IRON RIDGE FILING NO. 2

TYPICAL SECTIONS

STREET IMPROVEMENTS

POND 2 GRADING

1. COLT COURT STA: 5+00 - 8+24.14
2. POSTED SPEED = 25 MPH
3. DESIGN SPEED = 30 MPH
4. SEE GEC PLANS FOR ROADSIDE SWALE LINING REQUIREMENTS

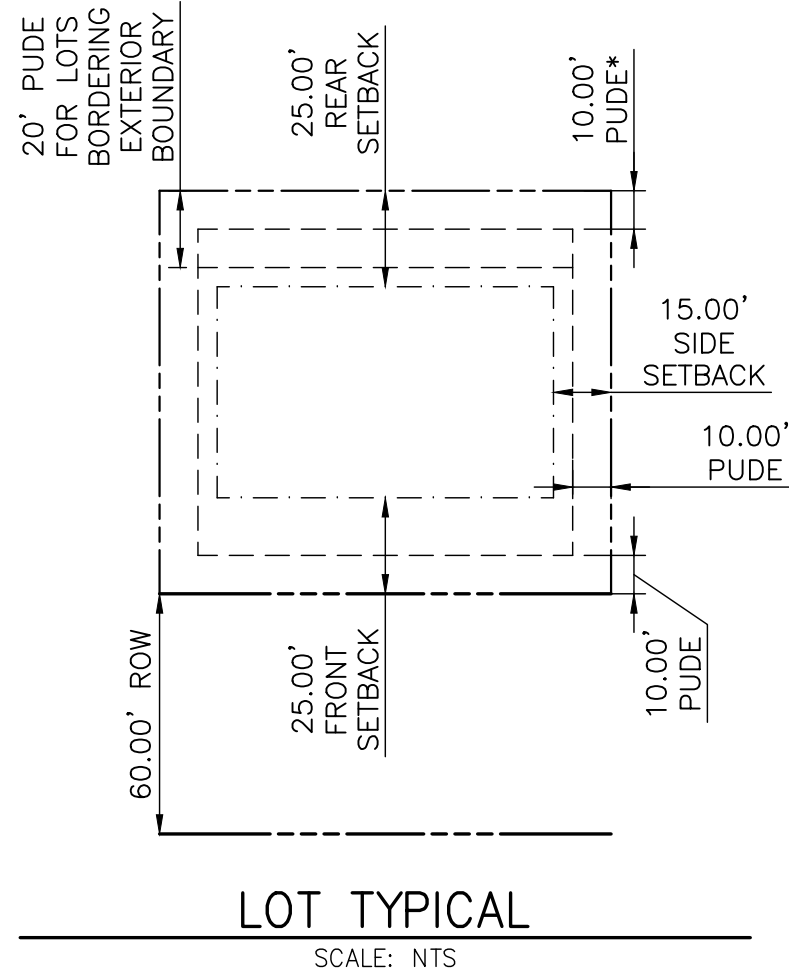
Unresolved V1 Comment: This road segment does not conform to the standard cross-section for a rural local road per El Paso County ECM standards. Please revise accordingly or submit a deviation request for review.

Note that the ECM Administrator reserves the right to deny any deviation request.

Per ECM Section 2.3.3.D.2: Superelevation shall be consistent with Table 2-8, the AASHTO Green Book, and CDOT M & S Standards. However, the maximum rate used for expressways shall be 0.060 and arterial roadways shall be 0.040. Superelevation is not permitted on roadways with design speeds less than 50 MPH.

COLT COURT - CUL-DE-SAC EOA
STA 1+00.00 TO 4+69.32

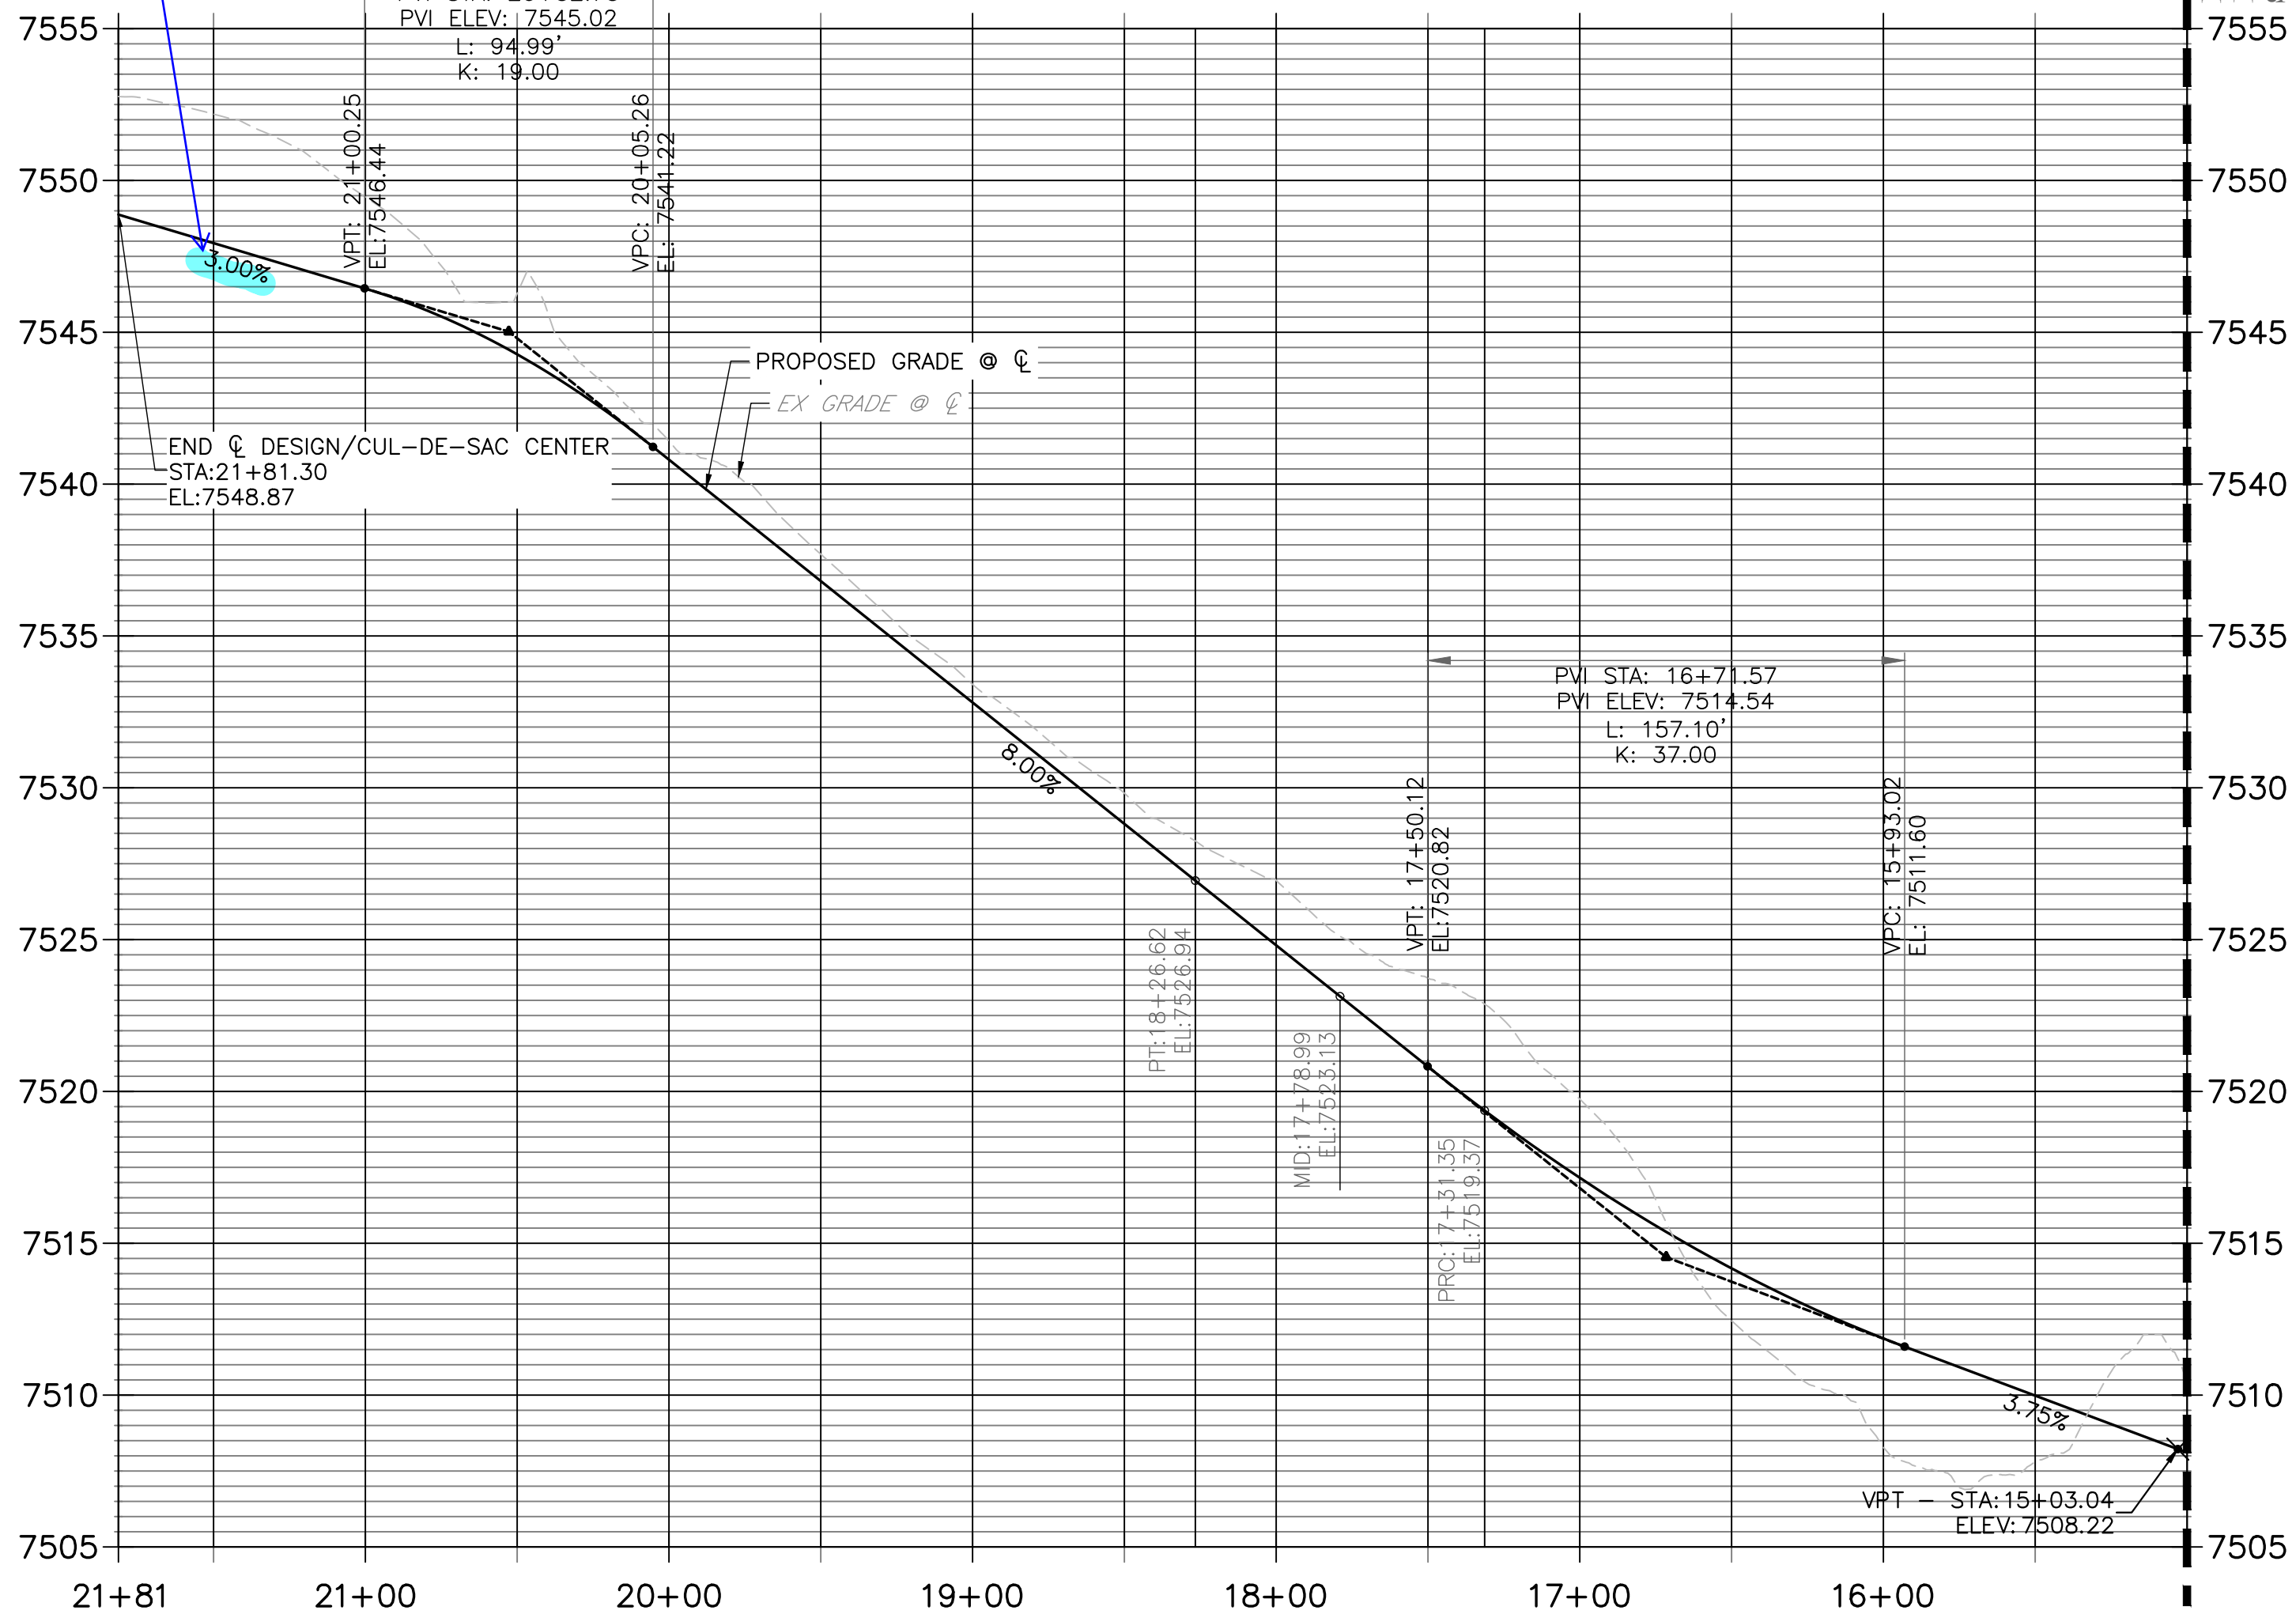
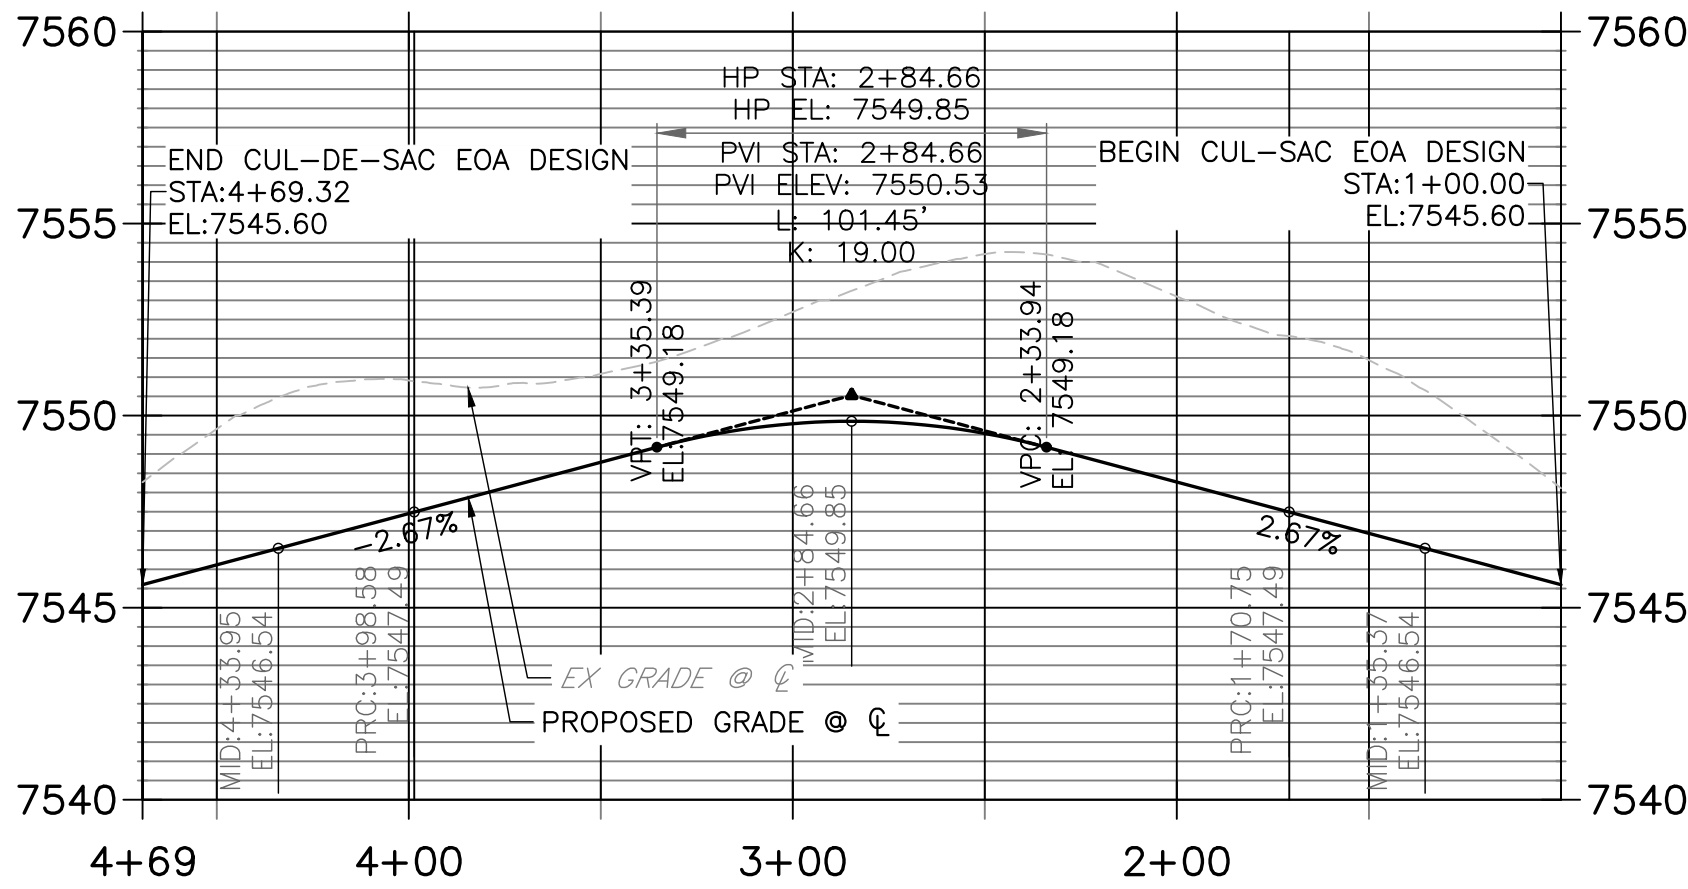
Unresolved V1 Comment:
Per ECM Figure 2-31 Typical
Cul-de-Sac Requirements
(Urban and Rural), maximum
slope for rural cul-de-sacs is
2%. Revise grading.

GEC PLANS

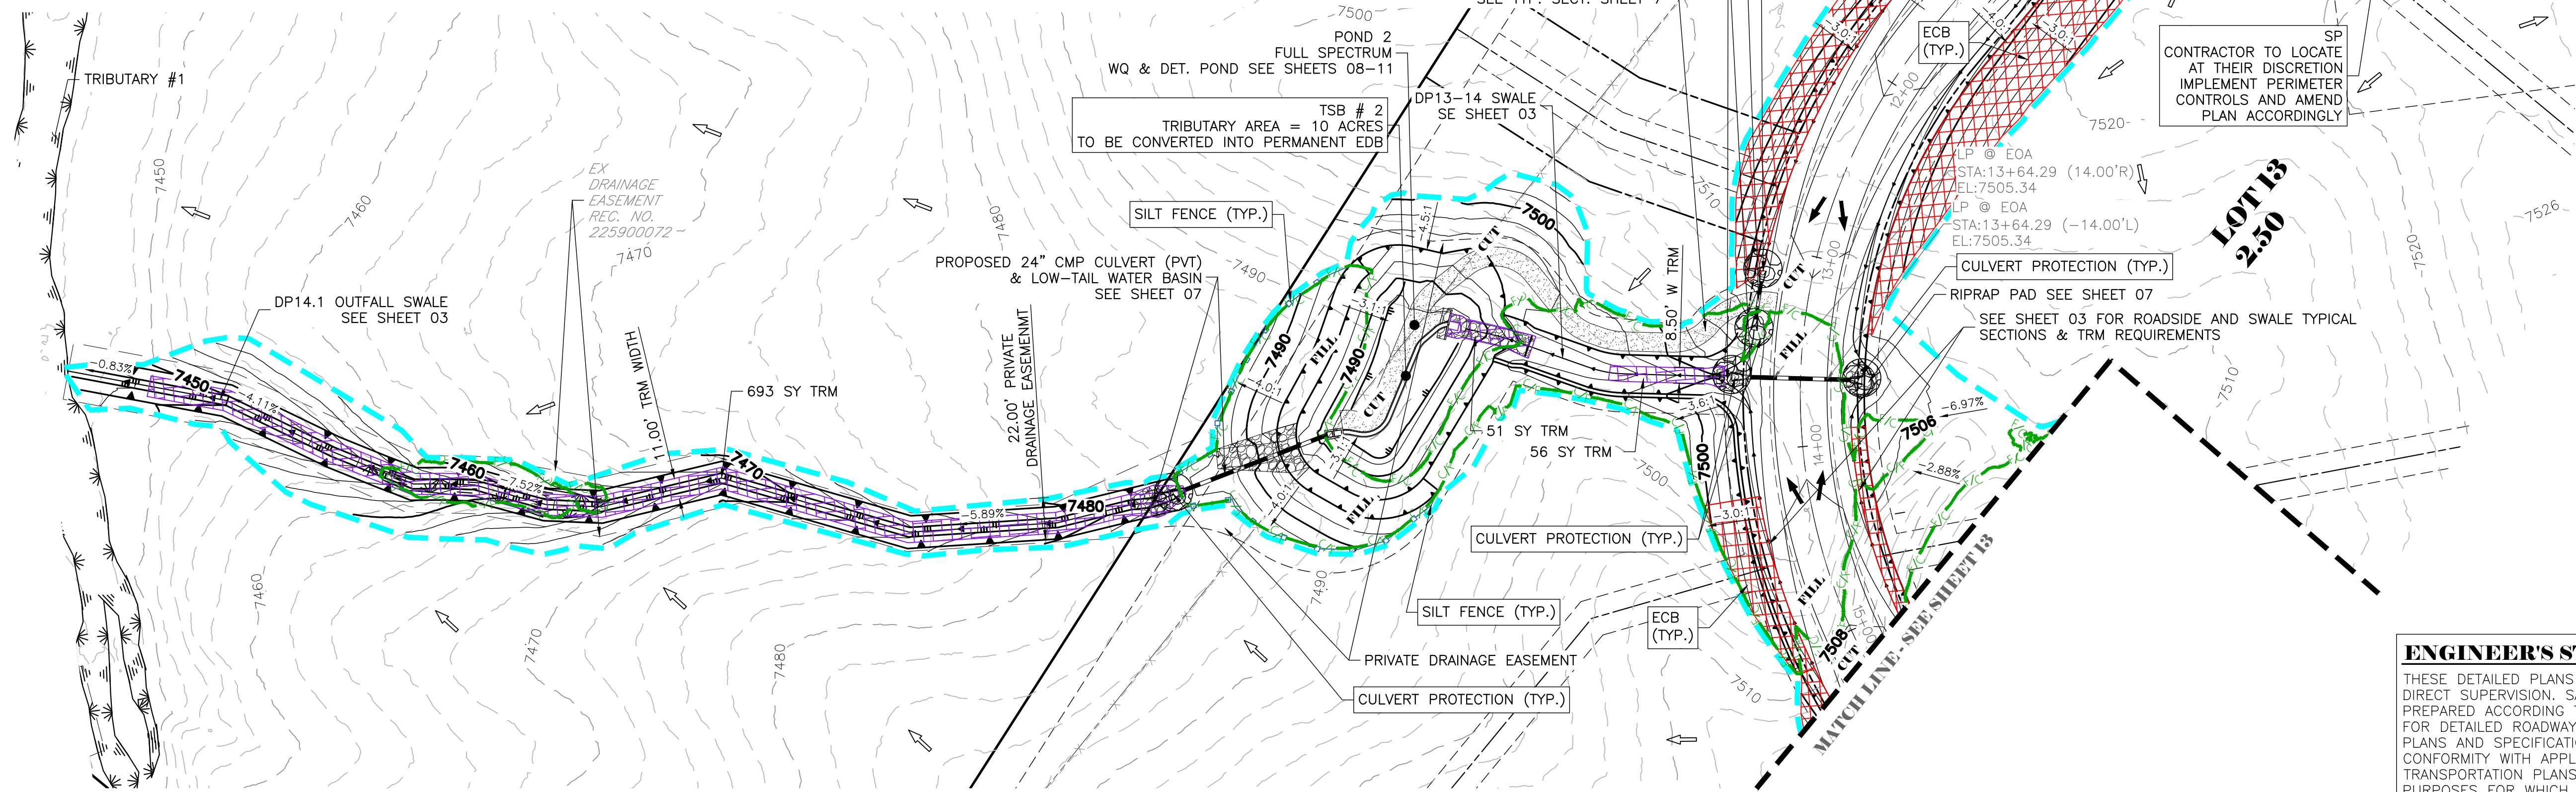
Show on plans or add a note clarifying that all disturbed areas not otherwise stabilized must be seeded/mulched
